MCI SERVICE LETTER #6

# SERVICE BULLETIN

PRODUCT JH-16

BULLETIN NO. 103

P.C. Bd. JH-100 Transport Analog Torque Bd. No. 26D1

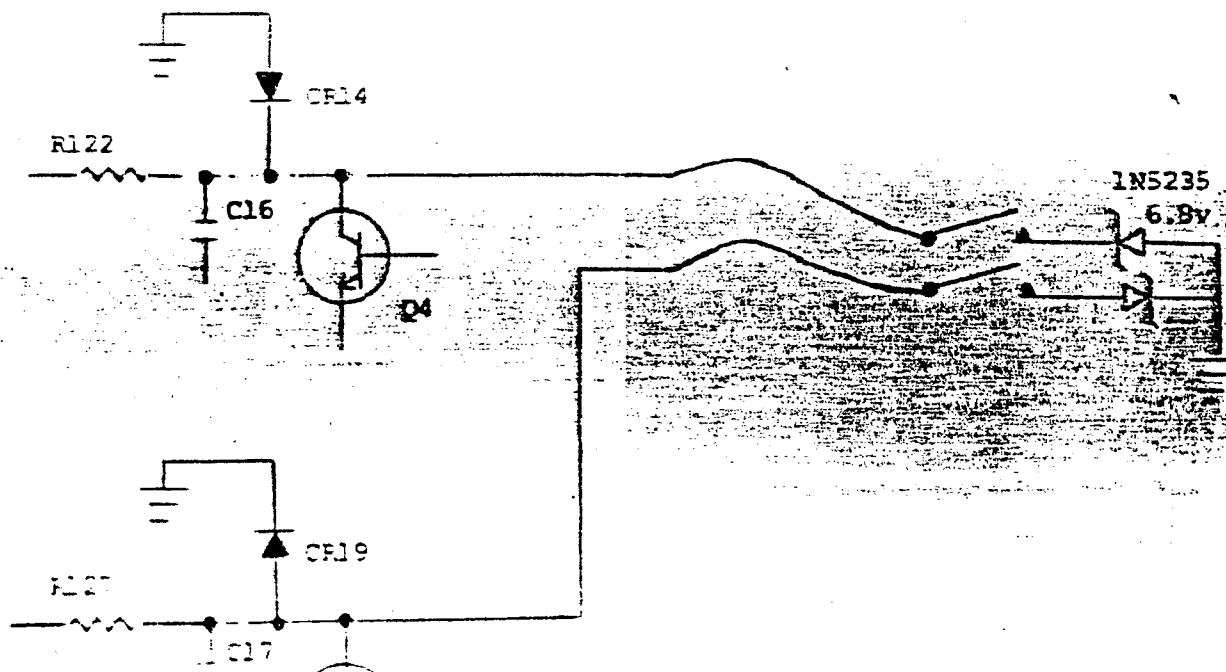
When thin tapes are used on JH-100 transports, the tension can be great enough to stretch the tape. If the customer has this problem, limit the torque by adding the components described below.

Diodes CR14 and CR15 must be shunted by 6.8v zeners (1N5235) to limit the back-bias voltage. The zeners must have the same polarity as the diodes:

If the machine is to be used for BOTH thin tapes and regular tapes, a DPST switch should be installed as follows:

Mount a mini-toggle switch in one of the vent slots in the transport electronics chassis. Connect as follows:

NOTE: CR19 on schematic is labeled CR17 on the board

1. K1 replacement card PCA9000B0124-00A (mounted on each Control Card)

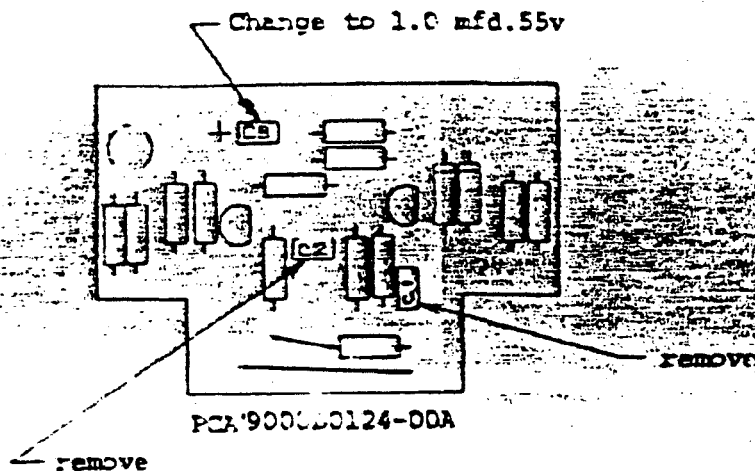
**REASON FOR CHANGE:** Complaints from the field point out that the PET Cards which replace the mechanical relays on the Control Cards are more noisy than the relays during Punch-in in Auto mode.

Clip out C1

Change C3 from .1 mfd to 1.0 mfd 55v. (observe polarity)

SEE SKETCH BELOW

**DO NOT MAKE THESE CHANGES ON THE K2 REPLACEMENT CARD.**

2. A few of these cards have a 2.2 mfd cap. (C2). This cap was deleted in later production. IF you are making the changes and IF the Card has a C2 (See sketch below) clip it out.

P.C.B.D. BIAS AMPLIFIER

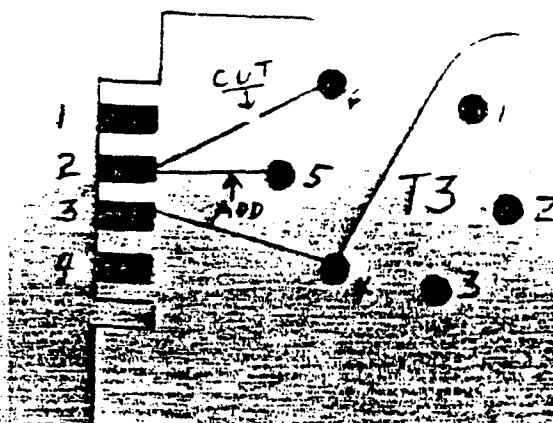
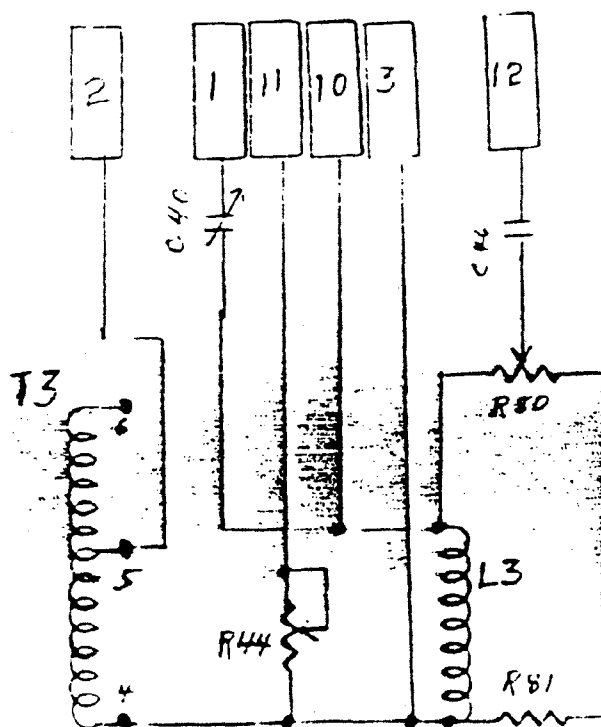
REASON FOR CHANGE: When using WOELKE ERASE HEADS, some interaction has been noted between channels. Also excessive adjustment has been needed when changing between 24 TRK and 16 TRK head assemblies.

DESCRIPTION OF CHANGE: SEE THE SKETCH BELOW

1. Cut the land between Pin 6 of T3 and Pin 2 of the edge connector.
2. Add a bus wire from Pin 5 of T3 to Pin 2 of the edge connector.
3. Change R81 from 1 k $\Omega$  to 240 $\Omega$ .

COMPONENT REQUIREMENT: per bias card - (1) 240 $\Omega$  1/2w 5%

P.C. Bd. BIAS AMPLIFIER No. 9000-0125

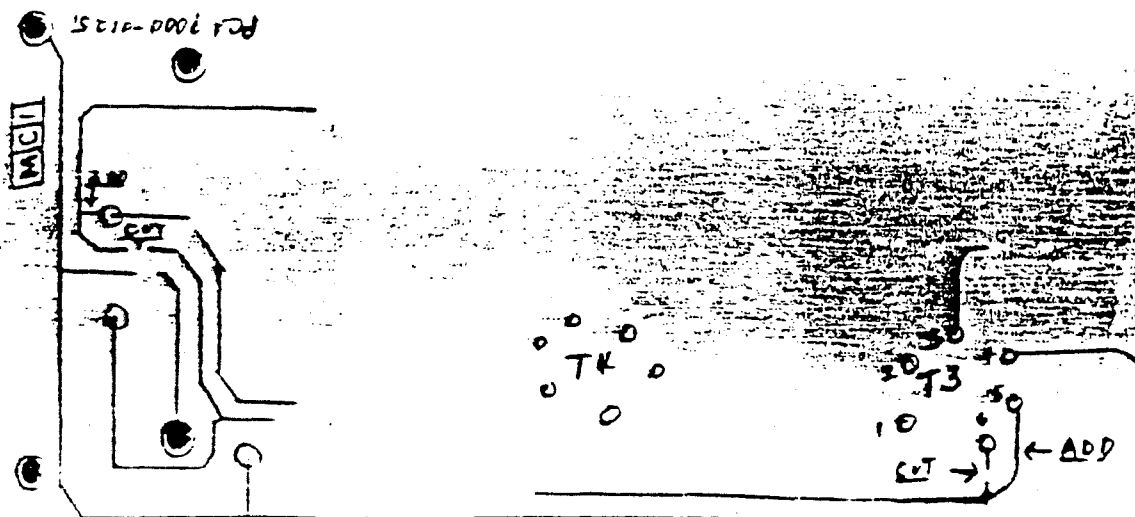
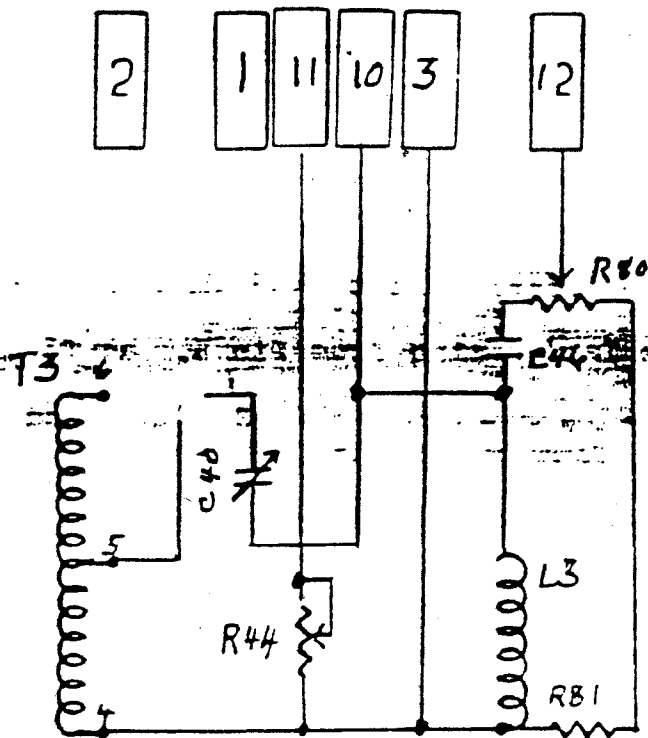
REASON FOR CHANGE: When using WOELKE ERASE HEADS, some interaction has been noted between channels. Also excessive adjustment has been needed when changing between 24 TRK and 16 TRK head assemblies.

DESCRIPTION OF CHANGE: SEE THE SKETCH BELOW and SCHEMATIC on next page

1. Remove C47, replace with bus wire.
2. Cut the land between C47 and C40 (trimmer)
3. Connect the output side of C40 (connects to Pin 10 of the edge connector) to the land which formerly came from C47.
4. Cut the land coming from Pin 6, at T3. This land goes to C40.
5. Install a bus wire from Pin 5, T3 to the land cut in the step above. (Connects T3, Pin 5 to C40).
6. Change R83 from 100 $\Omega$  to 47 $\Omega$ .
7. Change C42 from .01 $\mu$ f to .012 $\mu$ f.

COMPONENT REQUIREMENT: per BIAS card - (1) 47K 1/2 w 58.  
(1) .012uf cap.

PCA 9000-0125

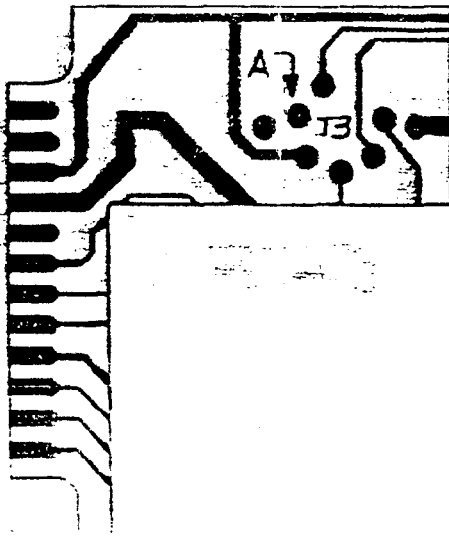
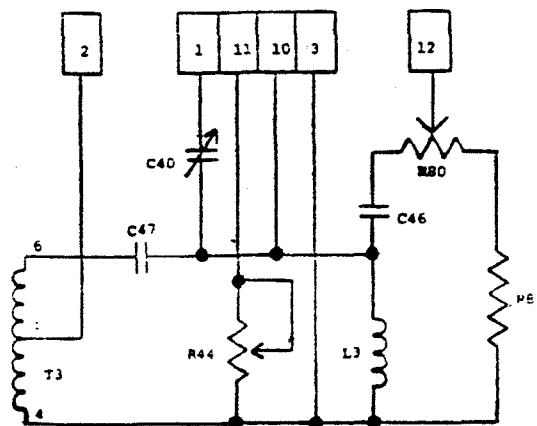
REASON FOR CHANGE: When using WOELKE ERASE HEADS, some interaction has been noted between channels. Also excessive adjustment has been needed when changing between 24 track and 16 track head assemblies.

Cut one lead and install one jumper on the circuit side of the board as shown below:

Check the following components and change values when necessary:

Check that you now have C40 connected to terminal 5 of T3

Check that you now have C47 connected to terminal 6 of T3

PCA 9000-0104

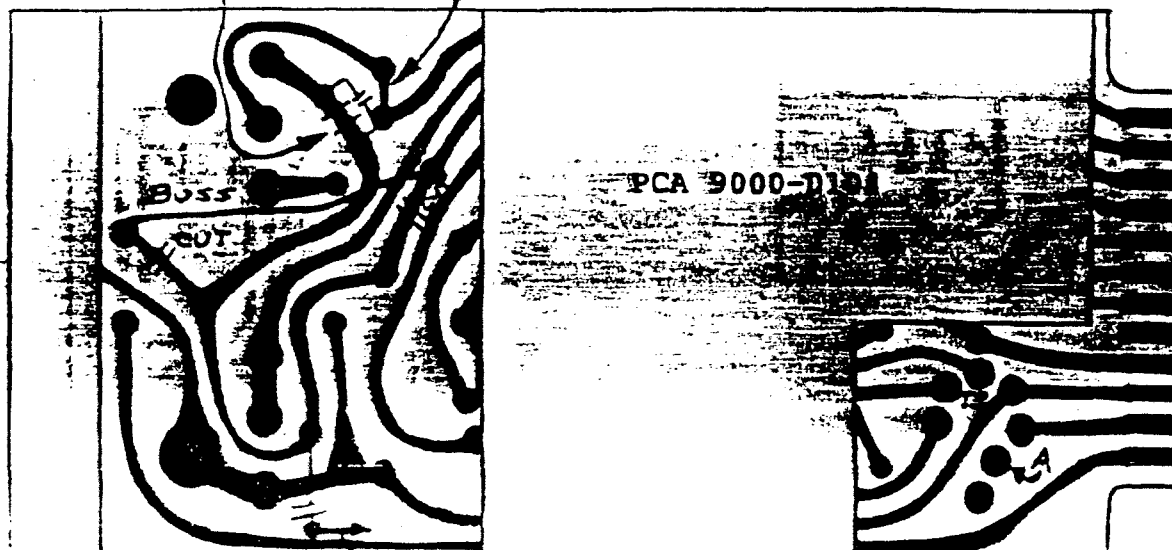
Refer to the sketch below: Cut 3 lands, Add 2 capacitors.  
Add 3 jumpers (2 on component side of the board).

Cut land and add C46 here

Buss out C46

1000pf Buss to Silver Point A

PC 9000C0005  
JH-10, JH-100

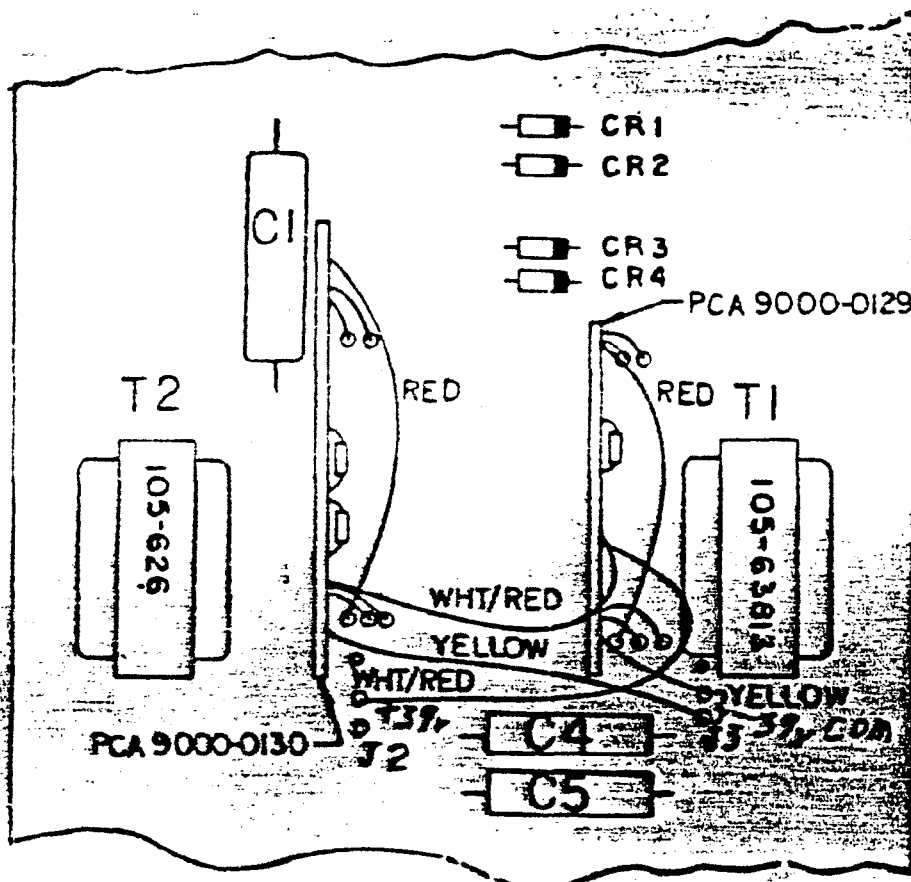
REASON FOR CHANGE: Sync relay switching noises can be eliminated by substituting FET switches for K1 and K2.

DESCRIPTION OF CHANGE: Remove K1, K2, and CR2. Remove J2 & J3 (The 3 pin Molex connectors nearest T1 & T2). Install PCA 9000-0129 and PCA 9000-0130 as shown by the sketch below.

CR2 must be removed to prevent feedback when doing OVERDUB in REMIX mode.

COMPONENT REQUIREMENT: PER CHANNEL: (1) PCA 9000-0129  
(1) PCA 9000-0130

P.C. BD. Master Status Board P.C. BD. NO. 2500-0231  
(Tape, Input, Auto)

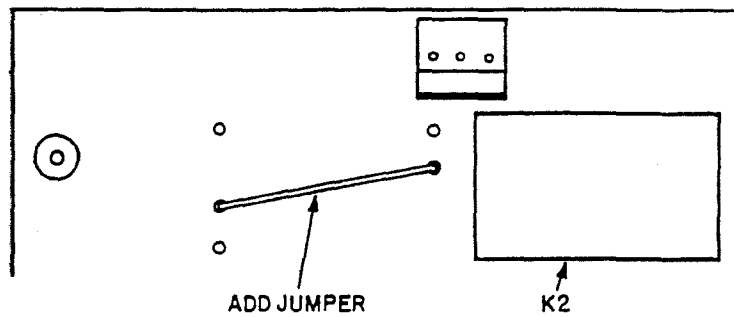
Eliminate switching noise of Sync Relay when in AUTO mode and channels are in Record Ready then switching transport from Play to Stop or Stop to Play.

This change allows the cue relay to remain in cue mode during Stop condition. Monitor is still in input mode.

Remove Relay K1 on Master Status Board and jumper common contact and normally open contact (see Illustration on reverse side).

P.C.BD. Auto Locator Logic Bd. No. P.C.25D04

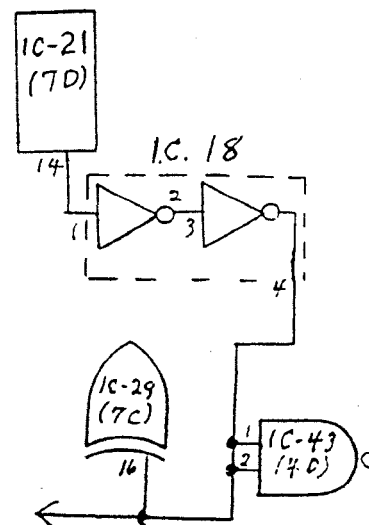
1. Disassemble the Auto Locator and place upside-down with Wrap-around TOWARD you. The I.C. pattern should look like the drawing on the back of this page.
2. Cut the land which exits UPWARDS BETWEEN Pins 11 & 12 of I.C. 29 (position 7C).

3. Install the following Jumper Wires as shown on the drawing.

- A. A Jumper from Pin 2 to Pin 3 of I.C. 18 (position 7E).
- B. A Jumper from Pin 1 of I.C.18 (7E) to Pin 4 of I.C.21(7D).
- C. A Jumper from Pin 4 of I.C.18(7E) to Pin 14 of I.C.29(7C).

The output of I.C. 21 was overloaded. This has resulted in the Subtractor working erratically. In some cases this I.C. has burned out.

This change makes use of two spare inverters (located in I.C. 18) to provide a buffer for the output line of I.C. 21.
